In accordance with the statewide Policy on the Use of Coastal and Estuarine Waters for Power Plant Cooling, Friends of the Earth respectfully urges this Board to order PG&E to install cooling towers at its Diablo Canyon nuclear plant on the earliest feasible timetable.

Powers Engineering Response to Bechtel Final Addendum: Back-to-Back Seawater Cooling Tower Design/Cost for DCPD Units 1 and 2

prepared for Friends of the Earth

Bill Powers, P.E., Powers Engineering, October 30, 2014

Figure 1. Base elevation of power block in DCPD turbine building¹¹

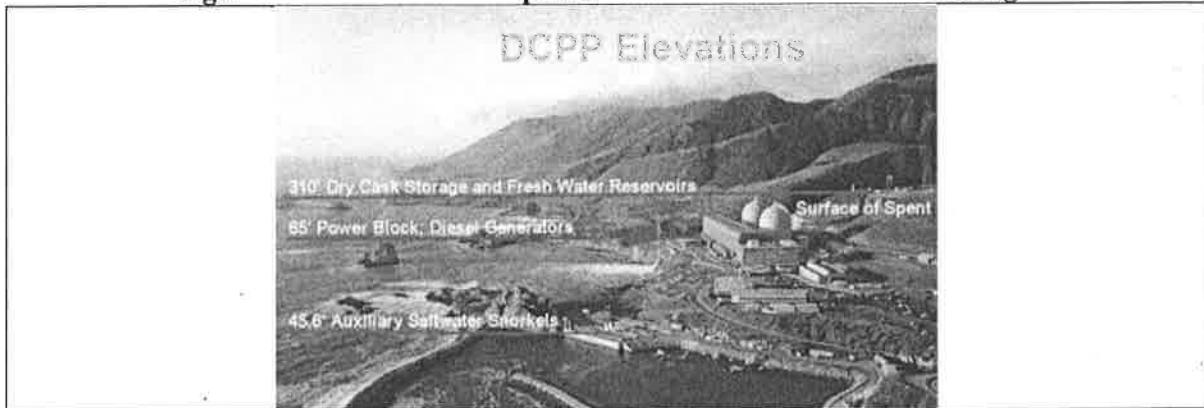
Bechtel's presumption that the existing elevation of the proposed cooling tower sites must be reduced, from 135 feet MSL and 131 feet MSL to an elevation of 115 feet MSL, is technically flawed. The existing circulating water ducts are designed for 50 psig service (115 feet hydraulic pressure).⁹ The Unit 1 and 2 surface condensers will be upgraded from 25 psig to 50 psig as a component of the cooling tower retrofit project.¹⁰ The low point in the existing water ducts is 43 feet MSL located underground in front of the DCP turbine building. The turbine building is shown in Figure 1.

There is no technical need to lower the elevation of the proposed cooling tower locations to 115 feet MSL to protect either the existing circulating water ducts or the upgraded Unit 1 and 2 surface condensers from overpressure.

Figure 7. Recommended placement of Unit 1 cooling tower using actual tower dimensions³⁸

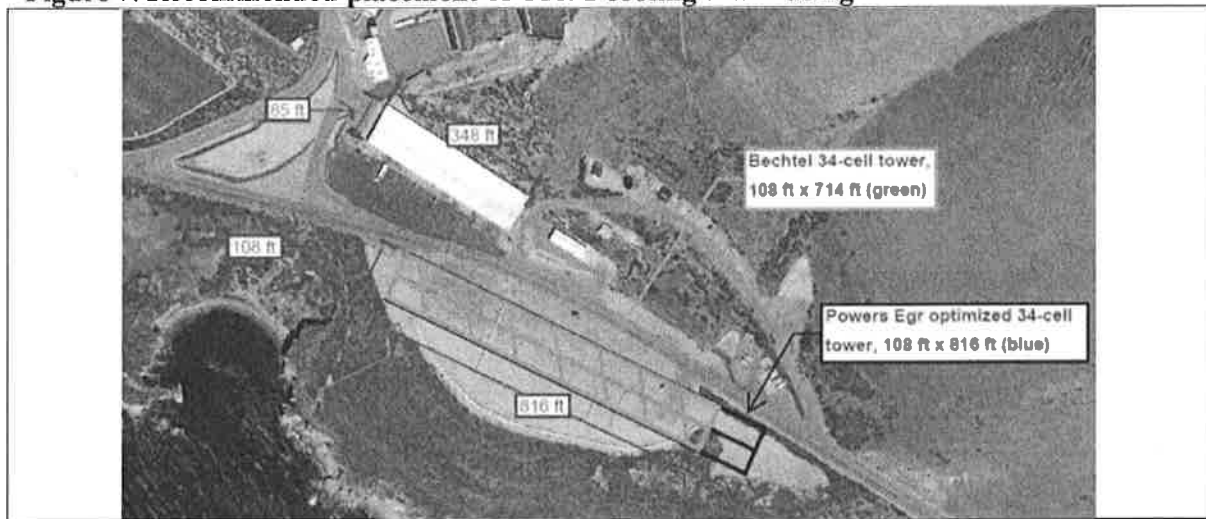
Candidate sites proposed by Powers Engineering for the Unit 1 and Unit 2 ClearSky™ cooling towers in these parking areas are shown in Figures 7 and 8. These locations are also shown as overlays on the Bechtel 34-cell cooling tower graphic in **Attachment A, Figure A-2**. The Bechtel 34-cell design, when the correct dimensions of the specified cooling tower cells are used, is significantly shorter than the 34-cell optimized design evaluated by Powers Engineering and fits more easily in available parking areas. The 34-cell Bechtel cooling towers, using the correct cooling tower dimensions as provided by manufacturer SPX, are also shown as overlays in Figures 7 and 8 for comparative purposes.

Figure A-2. Powers Egr preferred sites for 34-cell Bechtel cooling towers using correct 17 cell x 2 cell L x W dimensions

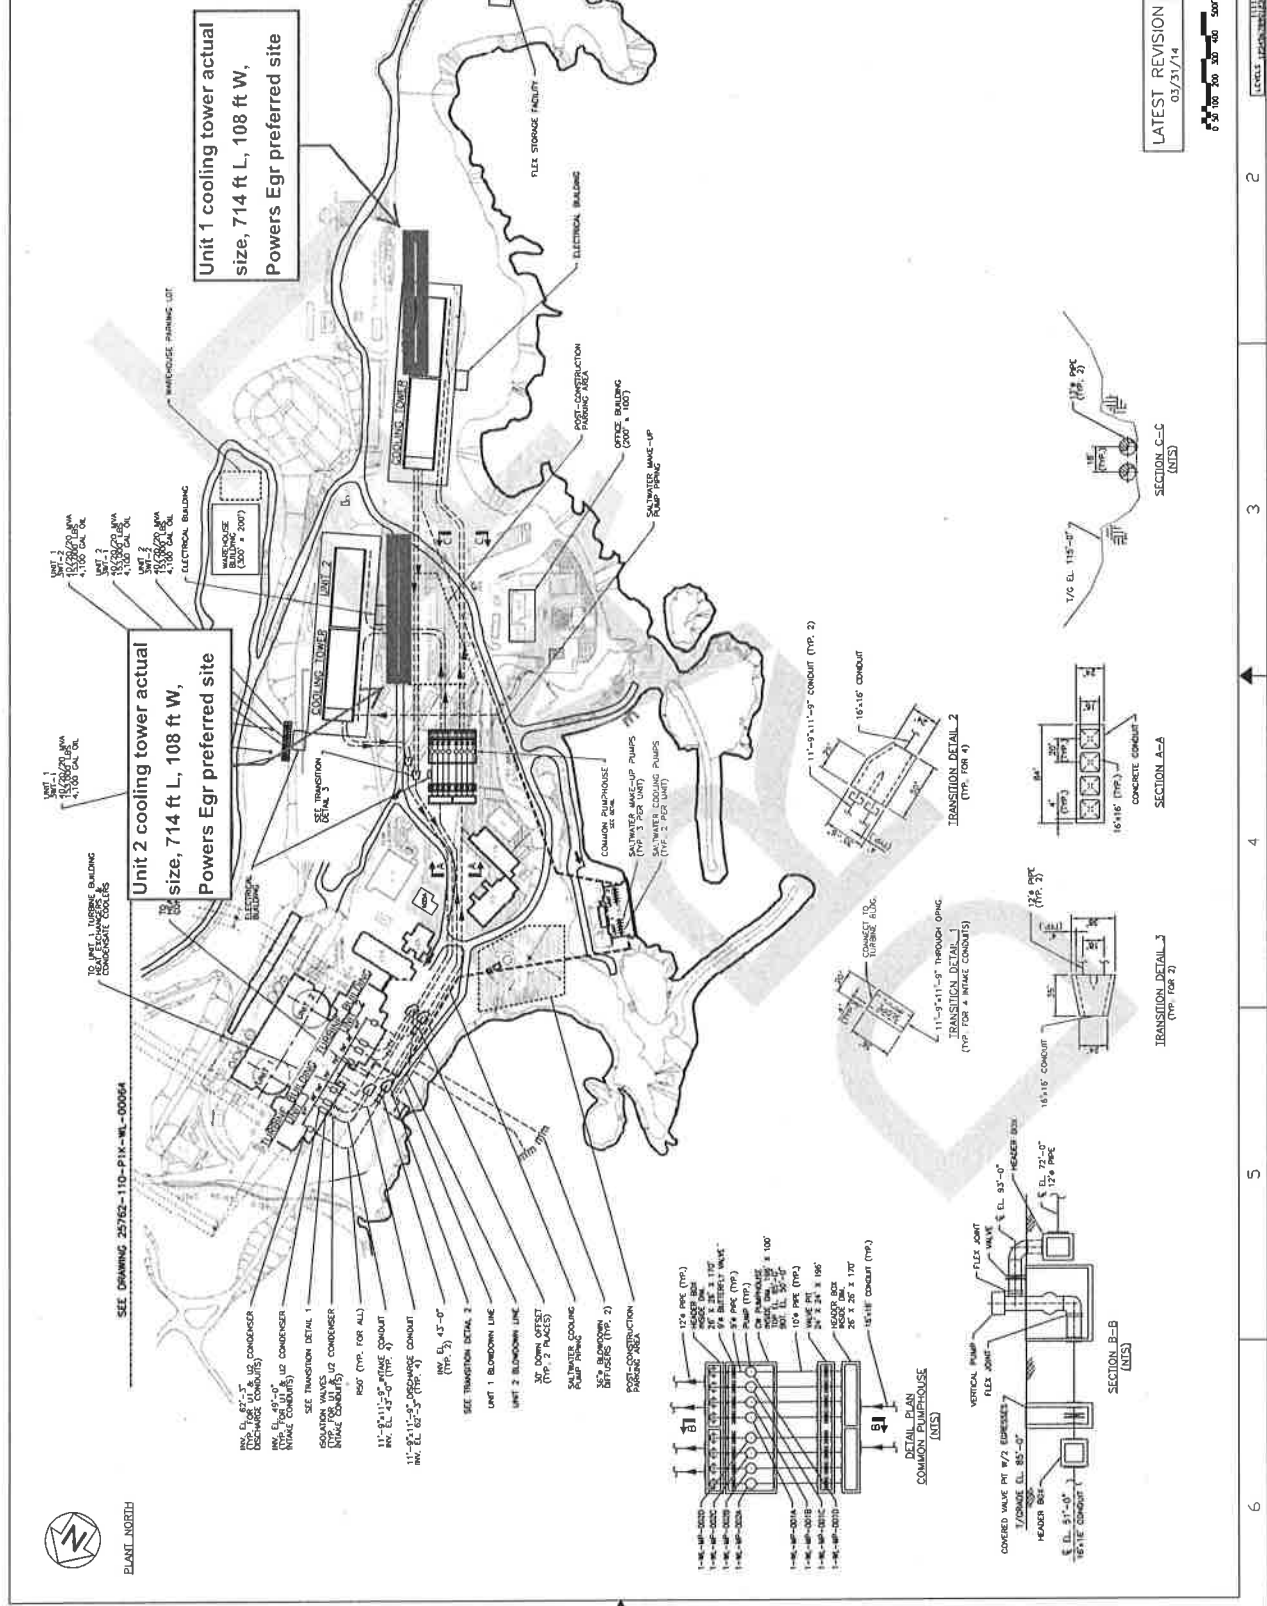
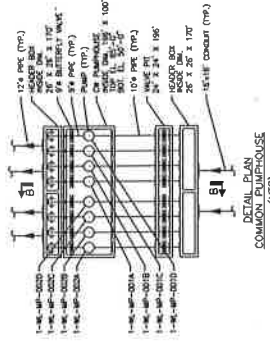
shown in **Attachment A, Figure A-2**, the Unit 1 and 2 cooling towers are substantially more compact than indicated by Bechtel and fit in existing unmodified parking areas.

Unit 1 cooling tower actual size, 714 ft L, 108 ft W, Powers Egr preferred site

Unit 2 cooling tower actual size, 714 ft L, 108 ft W, Powers Egr preferred site
